**Appendix B: Request for and Approval of Removal of Mechanical
Surface Aeration from Arcadia Reservoir**

Subject: City of Santa Monica Request to Remove Mechanical Surface Aeration Equipment from the Arcadia Reservoir Stipulated Under Permit Amendment 1910146PA-003

WATER SYSTEM 1910146 – APPROVAL TO REMOVE MECHANICAL SURFACE AERATION EQUIPMENT

Figure 2. Pounds per Day of VOC Removal from Decarbonator and Decarbonator with MSA

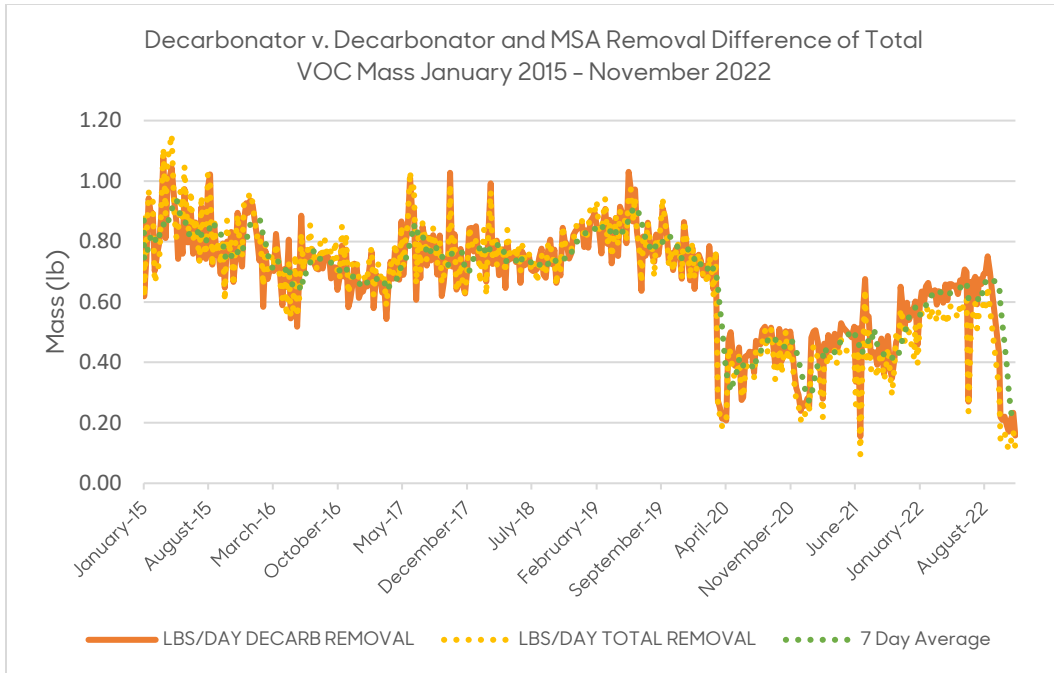
The mass VOC removal rate in pounds through the decarbonators alone compared to the decarbonators and MSA system for 2015 – 2022 is shown including TTHMs in Figure 2 and excluding TTHMs in Figure 3.

Historical water quality data collected since beginning operations of the Charnock Water Treatment Facility and Arcadia WTP provides compelling evidence that the Arcadia Reservoir MSA system does very little to impact VOC removal. Declining since 2016, the MSA system has removed less than 5% of the combined VOCs, excluding TTHMs. The poor removal efficiency of MSA equipment is in part due to the influent concentration of water entering the Arcadia Reservoir. The influent VOC concentration is rarely above the detection limit for reporting (DLR) of 0.5 ppb for target VOCs designed for MSA removal such as TCE, PCE, and 1,1-DCE. The only VOCs still present after decarbonator towers are TTHMs and TCE. Even then, MSA equipment does not show a significant decrease in TTHM's. From 2020 – 2022, VOC concentrations, although still near the DLR, appear to show a slight increase in the Arcadia Reservoir effluent than the influent. This is attributed to statistical variations within the analysis methods at concentrations near the DLR. Based on the historical data, it is evident that MSA equipment and the operating requirements associated with it provide limited benefit in the way of VOC removal.

After reviewing the enclosed documents, the Division of Drinking Water (Division) hereby approves the City's proposal to remove the MSA equipment at the Arcadia Reservoir. The Division also hereby repeals Condition 37 of 1910146PA-003-Revised, which was issued on February 27, 2014. Monitoring of VOCs and other contaminants will continue as normal. If you have any questions, please contact Mr. Matthew Megill at (818) 551-2033 or at Matthew.Megill@waterboards.ca.gov.

City of Santa Monica, California	Kennedy/Jenks/Chilton
ARCADIA WATER TREATMENT PLANT EXPANSION	RESERVOIR MODIFICATION
	DUCT PLAN, SECTIONS, AND DETAILS
Checked: M.L.	8/14/80
Designed: R.W.R.	7/14/80
Drawn: C.C.Z.	7/14/80
Scale: 1/4" = 1'-0"	
Job No. 894000.00	
Drawing No.	
M-9	39

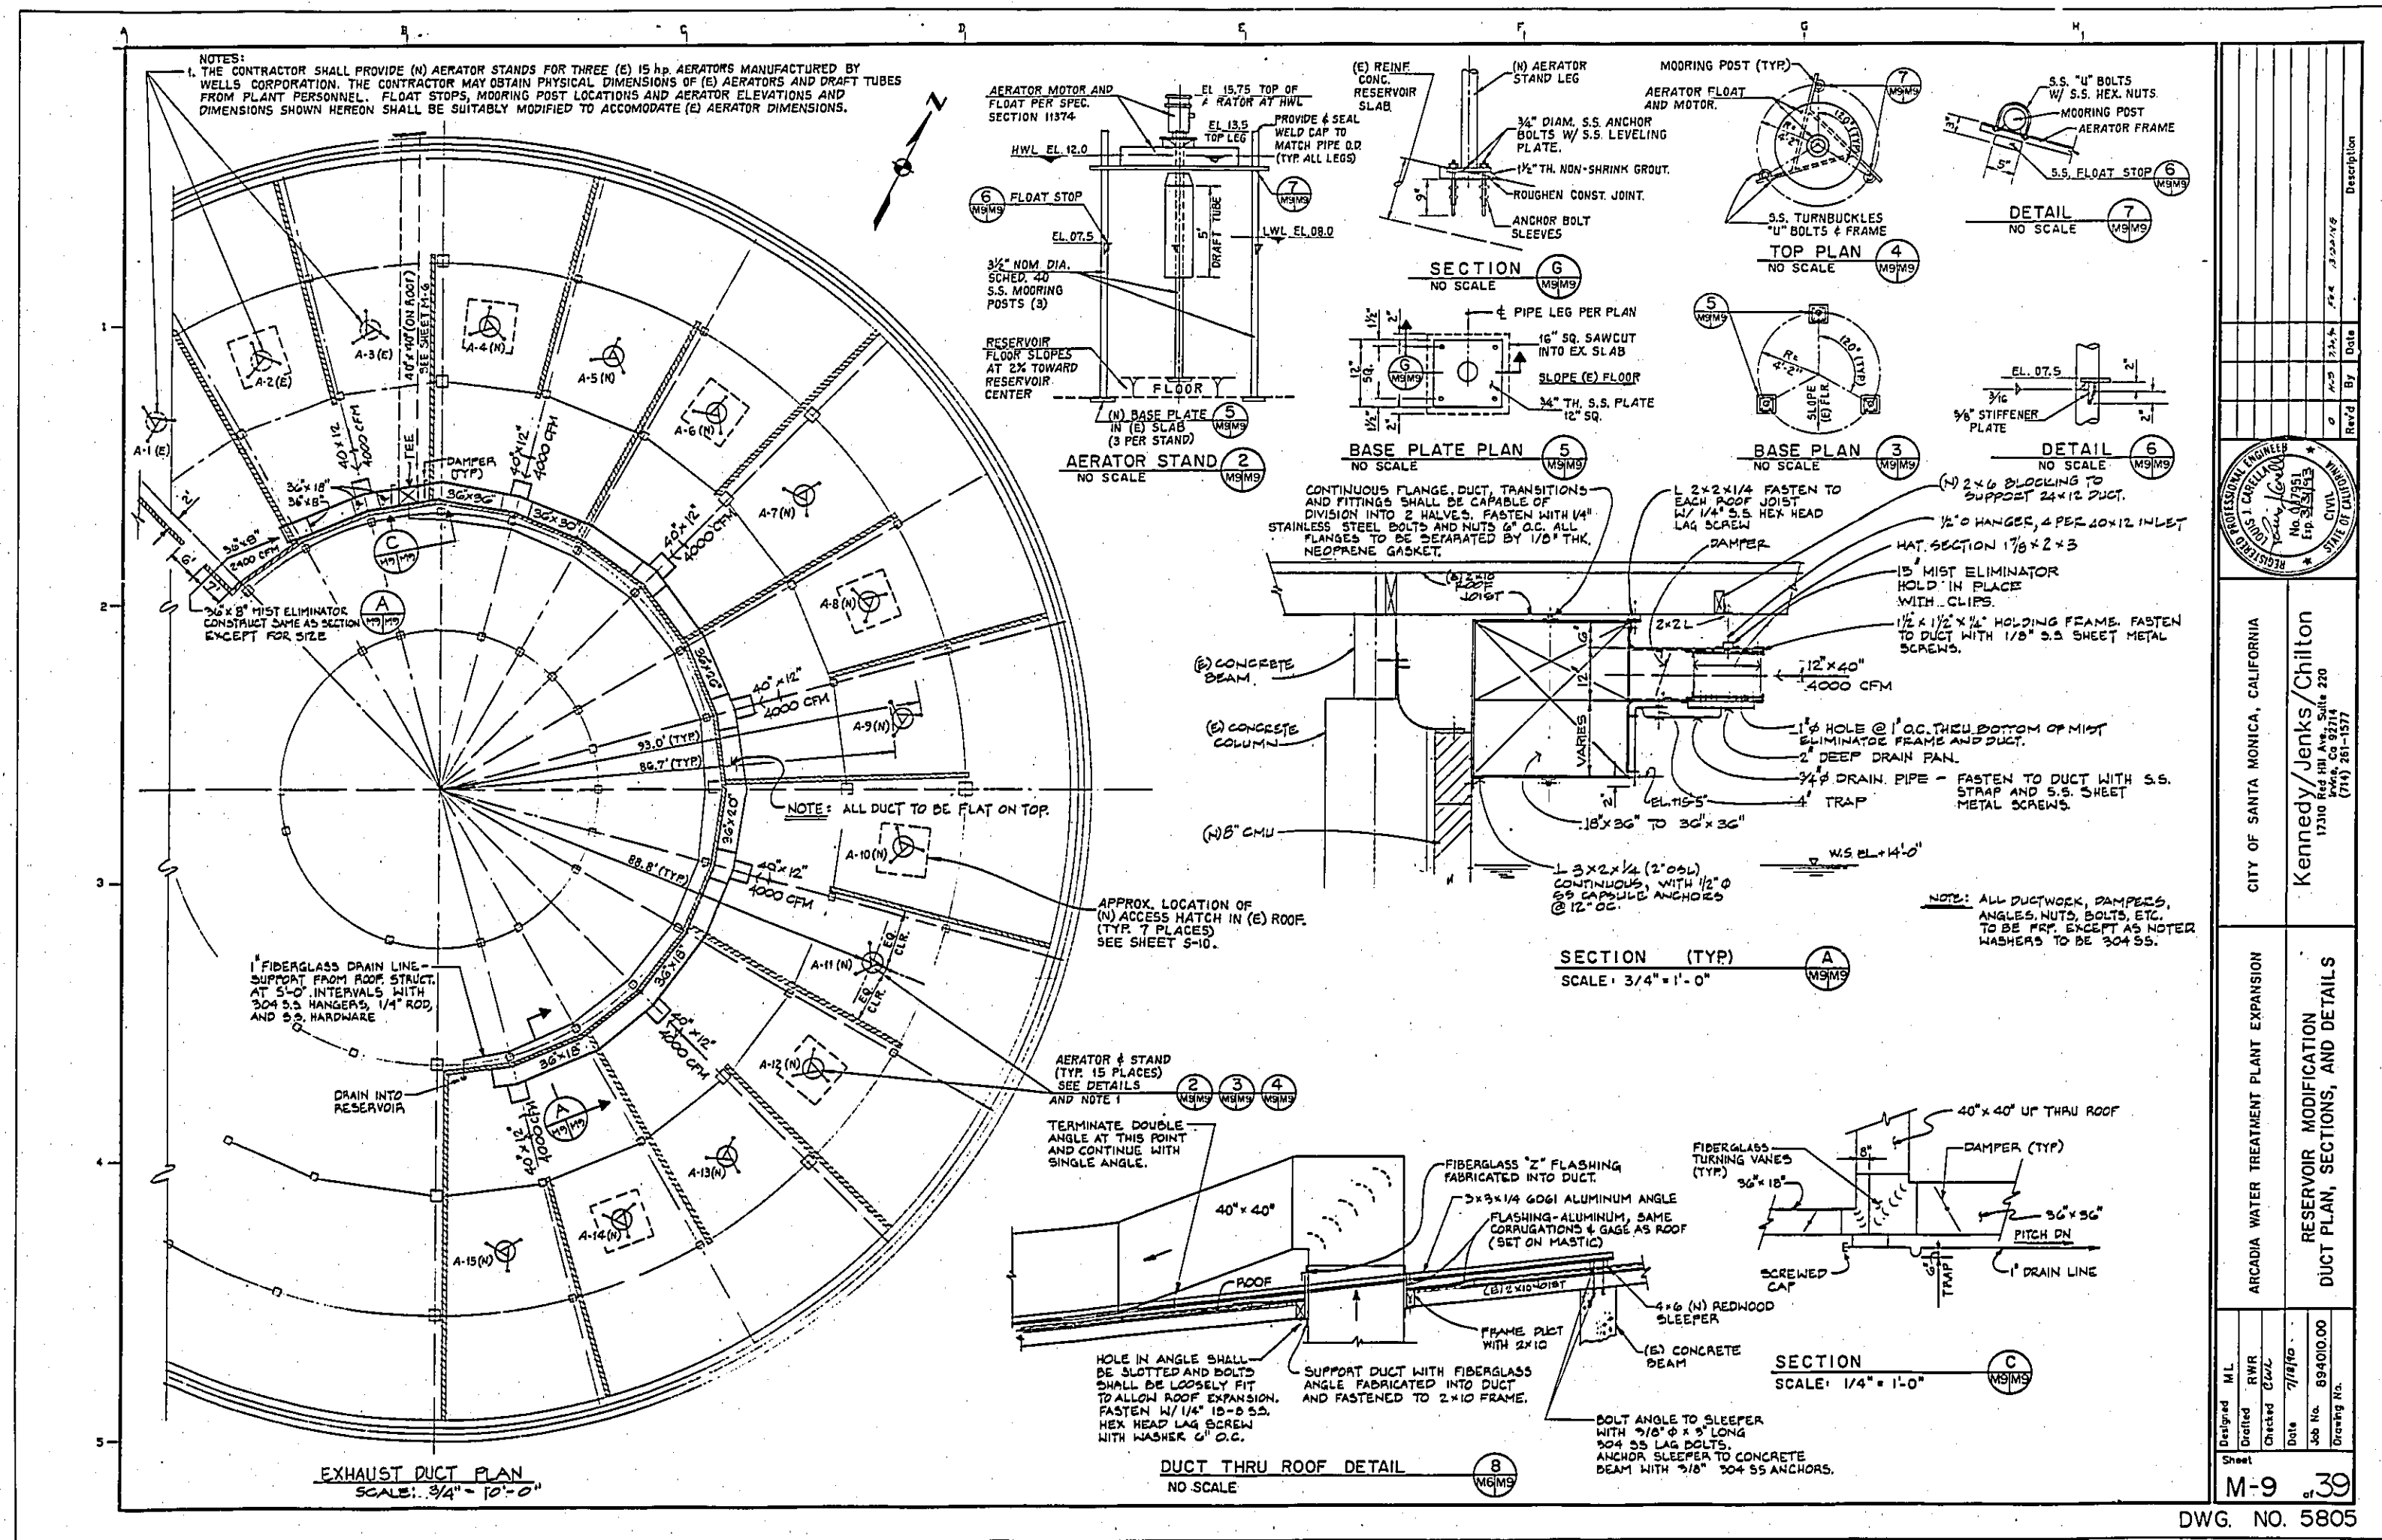
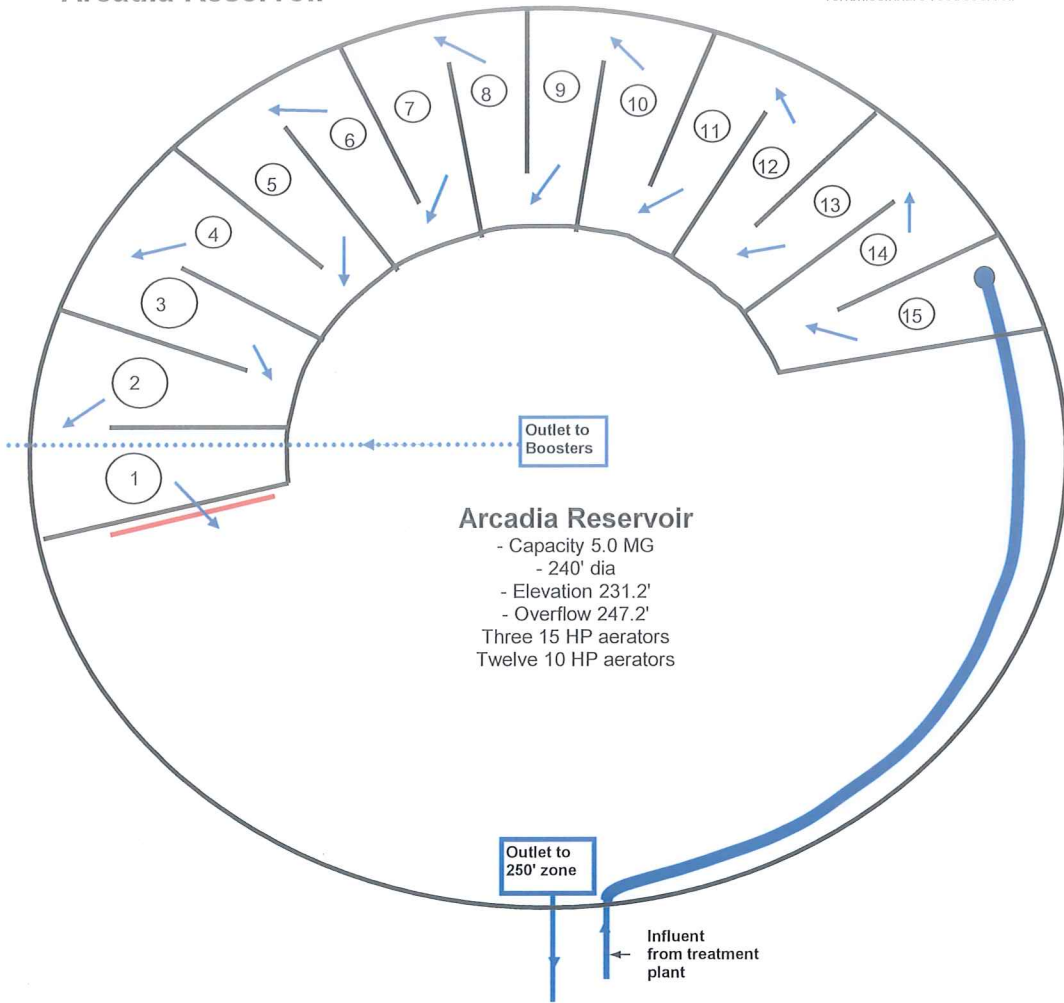
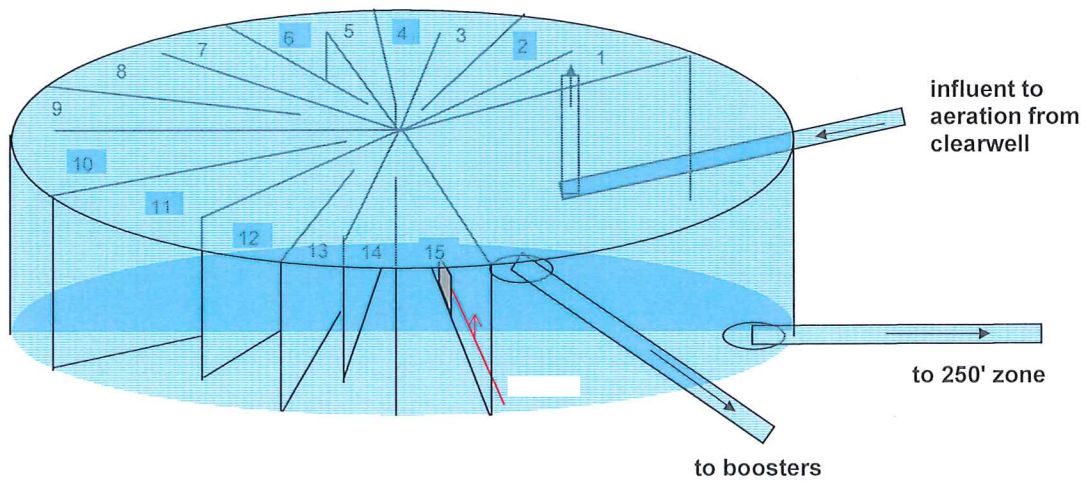
spray the water up into an airstream, and the air is collected into a square duct for further treatment through the vapor phase activated carbon adsorption unit. Approval for the MSA treatment in Arcadia Reservoir was provided by the California Department of Public Health letter in July 1992. An as-built drawing and schematic representation for the MSA system are included in Attachment A.

The MSA system operating requirements also induce significant constraints on the operational controls for the Arcadia Reservoir. MSA equipment limits the usable storage of the Arcadia Reservoir due to the intake structure of each aerator requiring a minimum water depth of 8 feet to operate. Too low of a reservoir level would render the aerators inoperable or else risk permanent damage to the equipment. The high-water level height in the reservoir is 12 feet which means there is a significant amount of water always required in the tank, regardless of system demand. Requiring over 8 feet of water to support MSA operations has impacted water age, chloramine residual, and disinfection byproduct formation as seen in the data presented in this letter with respect to TTHMs. Removing the MSA system would allow the City the ability to utilize the entire tank volume with regular drawdowns to reduce water age and mitigate the formation of disinfection byproducts, similar to how the City operates its other 3 drinking water reservoirs with a total storage volume of 40 million gallons. With further expansion at the Arcadia WTP underway, the Arcadia Reservoir will also have the expanded capability to supply water to all three distribution zones within the City making any further increased utilization a direct benefit to operations. By removing the MSA operating requirements, the City anticipates the ability to increase operational flexibility, add usable storage capacity, and improve water quality at Arcadia Reservoir and the overall distribution system.
